**ZONING AMENDMENT,
PLANNED UNIT DEVELOPMENT &
SUBDIVISION STAFF REPORT**

Date: September 15, 2011

<u>NAME</u>	Mr. Rooter Plumbing
<u>SUBDIVISION NAME</u>	Mr. Rooter Subdivision
<u>LOCATION</u>	2409 Wolf Ridge Road (Southwest corner of Wolf Ridge Road and Feed Mill Road [private street]).
<u>CITY COUNCIL DISTRICT</u>	District 1
<u>PRESENT ZONING</u>	R-1, Single-Family Residential District
<u>PROPOSED ZONING</u>	B-3, Community Business District
<u>REASON FOR REZONING</u>	Changing conditions.
<u>AREA OF PROPERTY</u>	3.4 Acres ±
<u>CONTEMPLATED USE</u>	<p>Subdivision approval to create one legal lot of record from an existing metes-and-bounds parcel, Planned Unit Development Approval to allow multiple buildings on a single building site with shared access between multiple building sites, and Rezoning from R-1, Single-Family Residential District, to B-3, Community Business District, to allow a commercial plumbing business.</p> <p>It should be noted, however, that any use permitted in the proposed district would be allowed at this location if the zoning is changed. Furthermore, the Planning Commission may consider zoning classifications other than that sought by the applicant for this

SITE PLAN

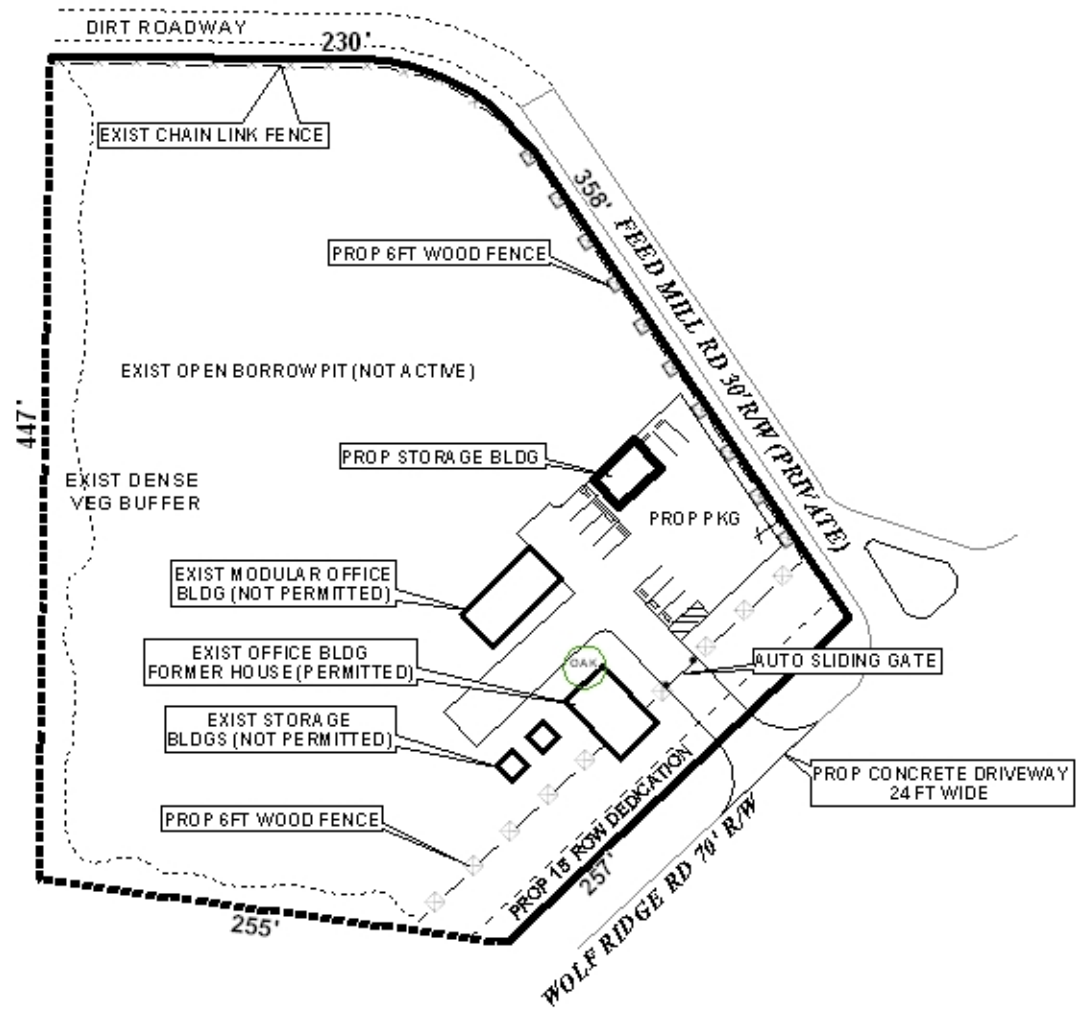
The revised Subdivision plat addresses the major concerns which prompted the original holdover for this application. Dedication is indicated to provide 50' from the centerline of Wolf Ridge Road, and the 25' minimum building setback line has been revised to be measured from the required dedication. As the lot would have over 200' of frontage along Wolf Ridge Road, a note should be required on the final Plat stating that the lot is limited to two curb cuts to Wolf Ridge Road, with the size, location and design to be approved by Traffic Engineering and conform to AASHTO standards. As Feed Mill Road is a private street, a note should be required on the Final Plat stating that direct access to Feed Mill Road is denied until such time it becomes a public right-of-way developed to City standards.

The lot is not labeled with its size on the plat; therefore, the plat should be revised to label the lot with its size in acres and square feet, after any required dedication, or a table should be furnished on the Final Plat providing the same information.

The revised site plan addresses the major concerns which prompted the original holdover for the PUD application. Dedication has been indicated along Wolf Ridge Road and the 25' minimum building setback has been revised accordingly. All un-permitted structures, fences, and parking areas are indicated to be relocated to compliant locations on-site meeting setbacks and/or allowing for frontage dedication. The driveway off Wolf Ridge Road is indicated to be a compliant 24' width, and the gate for such is indicated to be automatic; therefore, no vehicle stacking area would be required. Parking areas are indicated to be paved and compliant, and direct access to Feed Mill Road has been eliminated. A dumpster is not proposed; however a note on the site plan states that garbage will be placed in cans and removed either via private or public collection services. Although no frontage sidewalk is indicated, a note on the site plan indicates that a Sidewalk Waiver will be applied for if the PUD is approved or constructed if the Sidewalk Waiver is denied. The site plan also includes compliant landscaping, tree planting, and parking ratio calculations.

- 1) dedication to provide 50’ from the centerline of Wolf Ridge Road;*
- 2) illustration of the 25’ minimum building setback line as measured from any required dedication;*

- 3) placement of a note on the Final Plat stating that the lot is limited to two curb cuts to Wolf Ridge Road, with the size, location and design to be approved by Traffic Engineering and conform to AASHTO standards;*

- 4) placement of a note on the Final Plat stating that direct access to Feed Mill Road is denied until such time that it becomes a public right-of-way developed to City standards;*

- 5) labeling of the lot with its size in square feet and acres, or the furnishing of a table on the Final Plat providing the same information;*
- 6) placement of a note on the Final Plat stating that development of the site must be undertaken in compliance with all local, state and Federal regulations regarding endangered, threatened or otherwise protected species;*
